### REMARKS

Applicant's invention relates to a gas turbine combustor having a combustion chamber and annular premixing fuel passage

38-38 \_9-A•A-CROSS SECTION

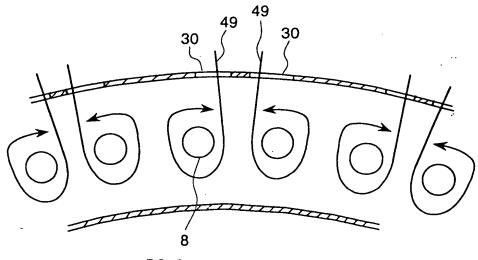
On page 2 of the Action, the Examiner indicated that the proposed drawing corrections received on December 15, 2003 were not approved because Fig. 39 needed correcting where the section view "A-A" needs to be designated by an Arabic or Roman numeral corresponding to the view number of the sectional view.

Being filed concurrently herewith is a letter requesting approval of changes to the drawings in which it has been requested that the section view designated "A-A" be deleted all together. This drawing change was approved in divisional application Ser. No. 10/334,068, now U.S. Patent 6,761,033 issued July 13, 2004.

In addition, Applicants are filing concurrently herewith a complete set of corrected formal drawings containing the drawing correction to Fig. 39 and the drawing corrections previously requested and which are identical to the drawing changes approved in divisional application 10/334,068, now U.S. Patent No. 6,761,033.
